PUBLIC HEARING MEMORANDUM

SUBJECT: **Petition #203-23** for SPECIAL PERMIT/SITE PLAN APPROVAL amends Special Permit #32-21 allowing for a larger driveway entrance width that exceeds the maximum allowed at **63-65 Broadway**, Ward 1, Newtonville, on land known as Section 13 Block 31 Lot 06, containing approximately 18,000 square feet of land in a district approved to be zoned MULTI RESIDENCE 1. Ref: 7.3.3, 5.1.7.C, 5.1.13 of Chapter 30 of the City of Newton Rev Zoning Ord, 2017.

63-65 Broadway

Site plan detail: building permit (left) and as built (right) driveway widths

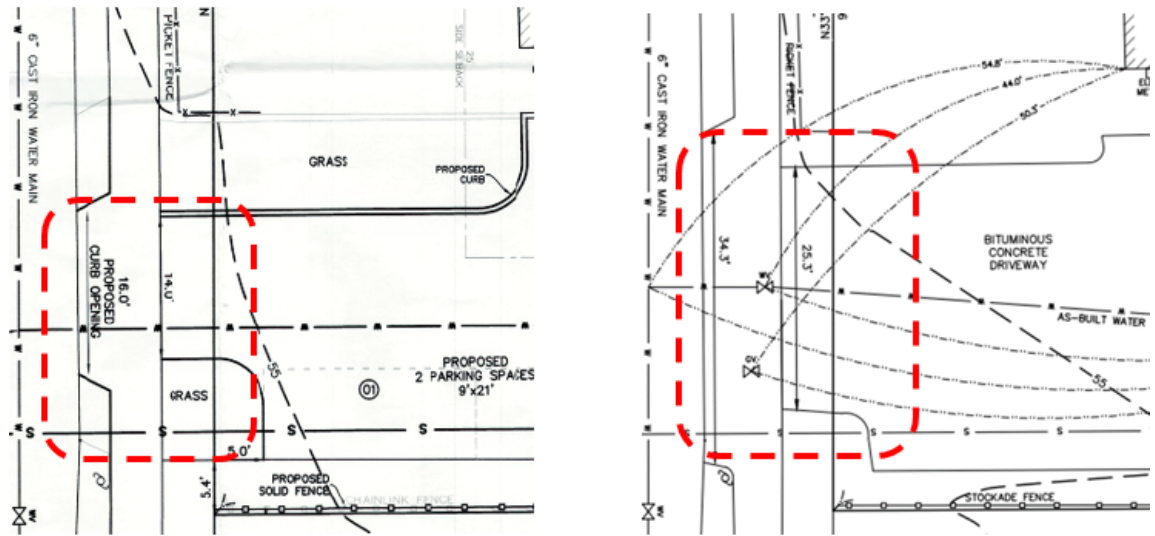
That said, the site design would be altered from that depicted in the building permit site plan (which satisfied Condition 4) to increase the allowed driveway width (as discussed below). The as built conditions increase the amount of impervious surface on the lot, reducing the open space from the approved 56.4% to 51.6% of the area of the lot, remaining above the minimum 50% required.

The driveway and associated curb cut serve two, two-car garages and provide space for additional outdoor parking. The petitioner seeks to amend the site plan associated with the previous special permit to allow an already constructed driveway with a width of 25.3 feet, which is in excess of both the 14 feet indicated in the special permit and the maximum 20 foot width established by Section 5.1.7.C

of the Newton Zoning Ordinance (NZO). The Planning Department notes that associated curb cut would retain the exiting width of 34.3 feet, which would be well in excess of the 16 feet indicated in the special permit-approved site plan.

The Planning Department is unclear as to why the approved driveway width cannot be in conformance with the special permit-approved dimensions.
